SUBJECT: HYDROLOGIC ENGINEERING INPUT TO THE BEAVER VALLEY-2 SER

Plant Name: Beaver Valley Power Station, Unit 2

HYDROLOGIC ENGINEERING INPUT
TO THE BEAVER VALLEY POWER STATION UNIT 2 SER

DOCKET NUMBER 50-508

2.2
FIGURE 4.3.1 PRINCIPAL HYDROLOGIC FEATURES

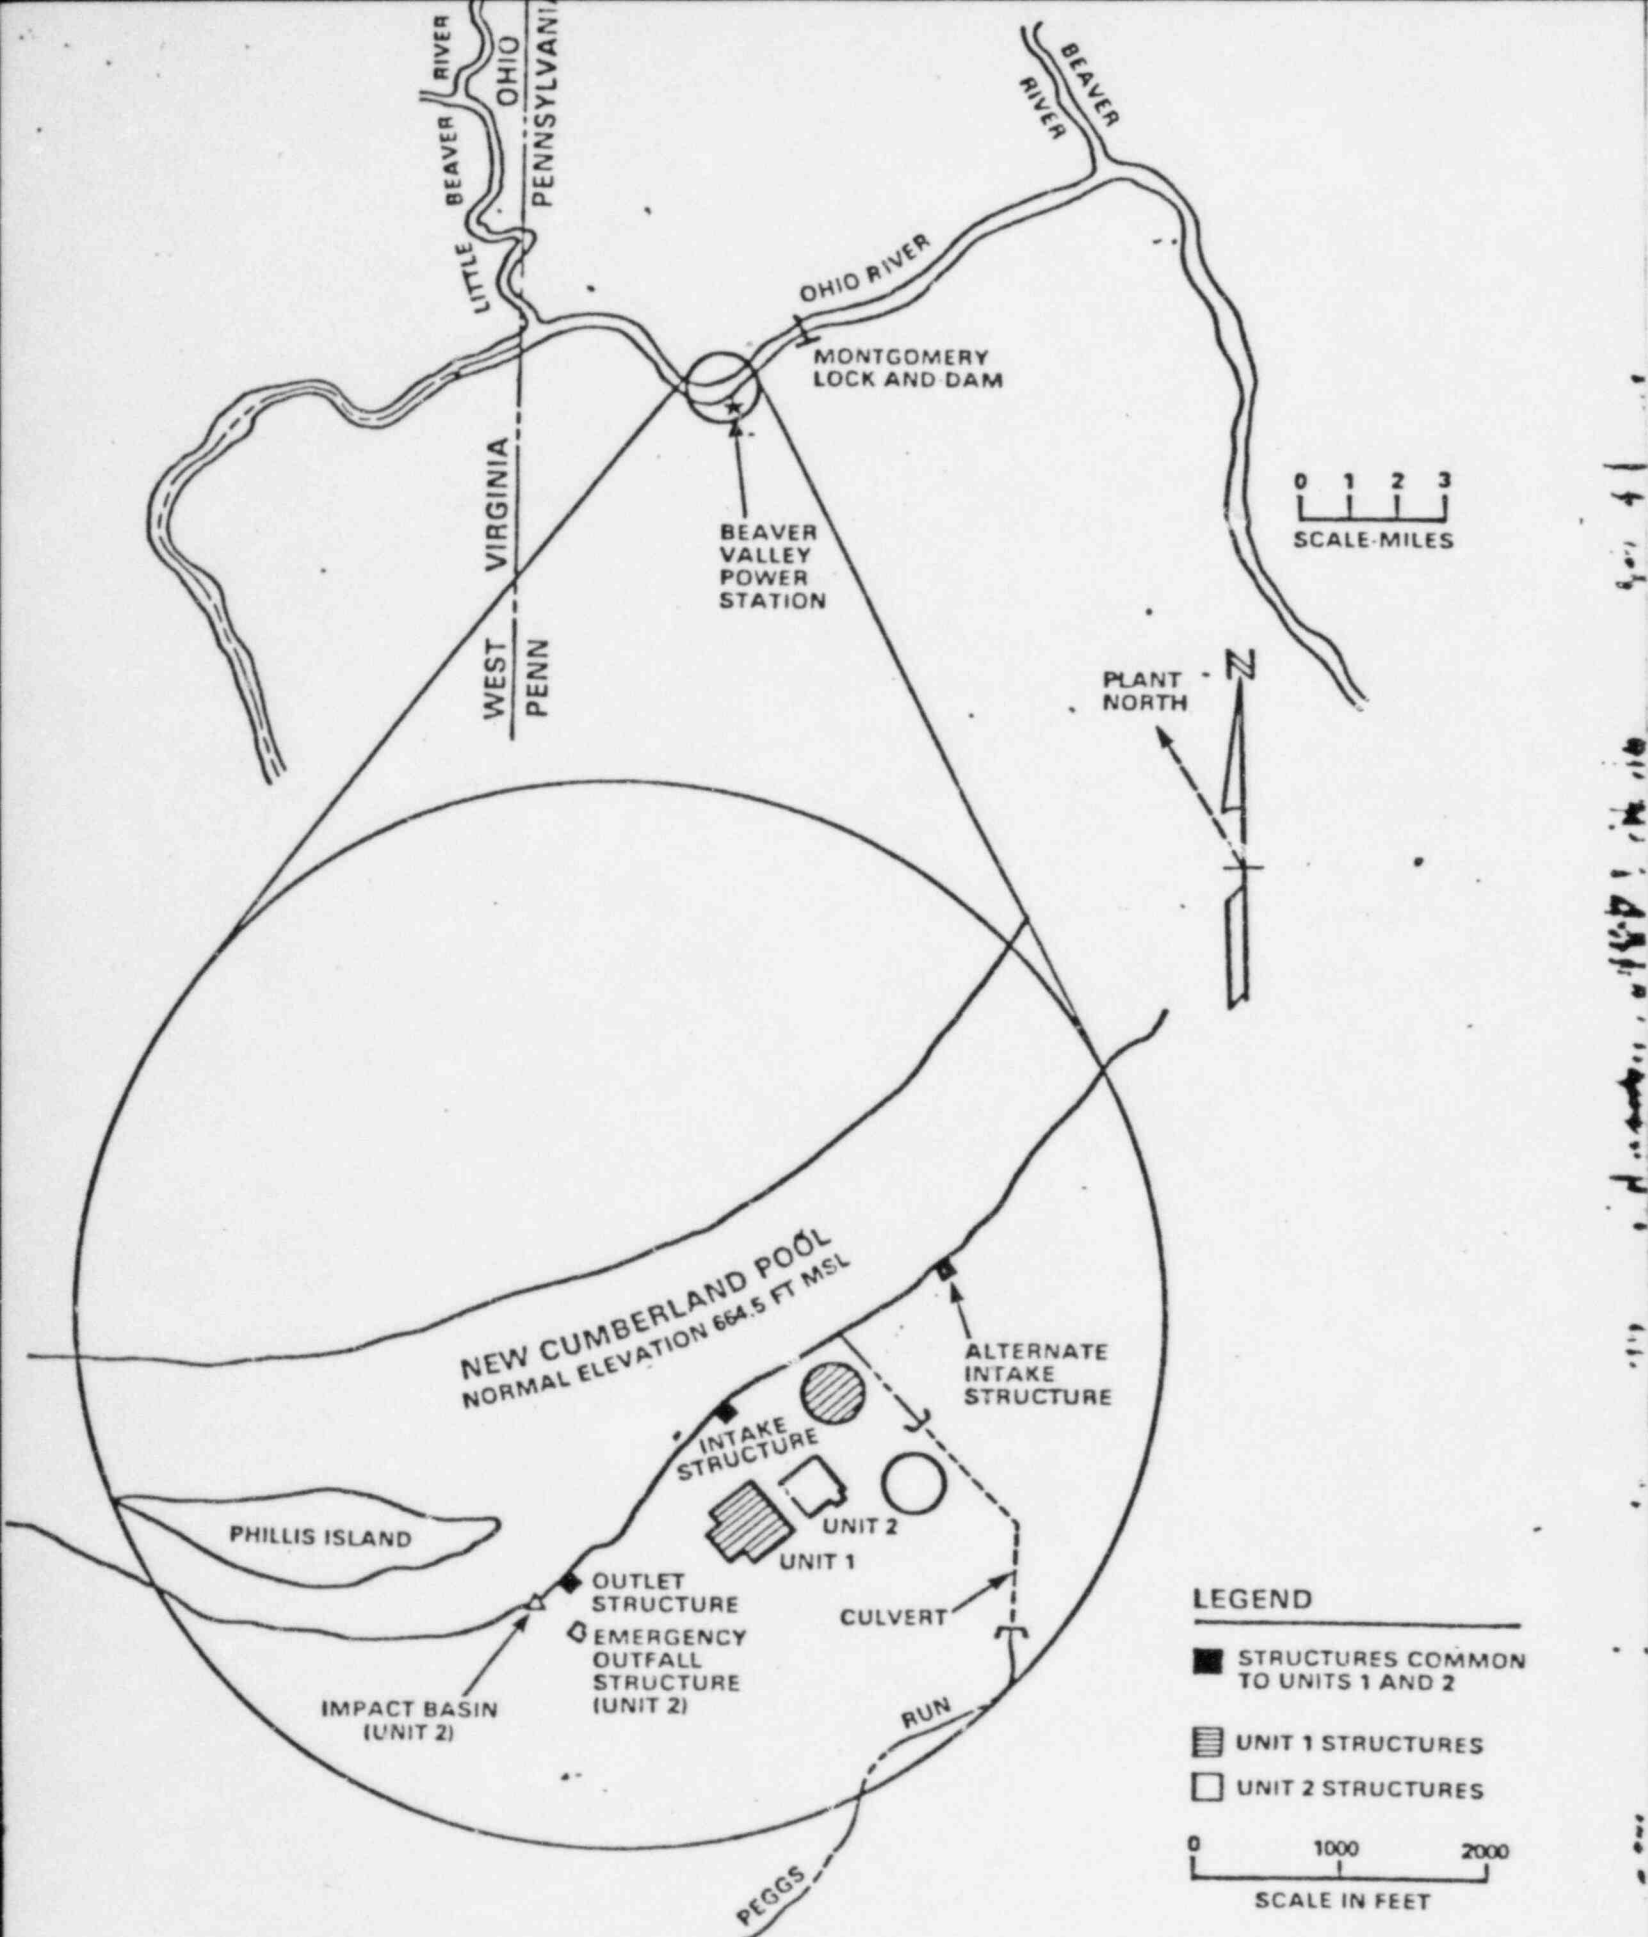
enclosed in a 15 ft diameter culvert so that the plant fill area could be extended across the Run. Location of the culvert is shown on Figure 2.2. The culvert empties into an open channel before entering the Ohio River. In analyzing the flood effects of a PMP event occurring over the Peggs Run drainage area, the applicant assumed that the 15 ft culvert was blocked. The applicant concluded that water levels in the vicinity of safety-related structures, due to flooding from Peggs Run, would be below the minimum station grade elevation of 730 ft-4 in msl.

The staff has reviewed the material presented in the FSAR and concludes that the applicant has not provided sufficient information to support its conclusion that flooding from Peggs Run will not affect safety-related buildings. The staff will complete its review following receipt, from the applicant, of responses to staff questions concerning flooding on Peggs Run.
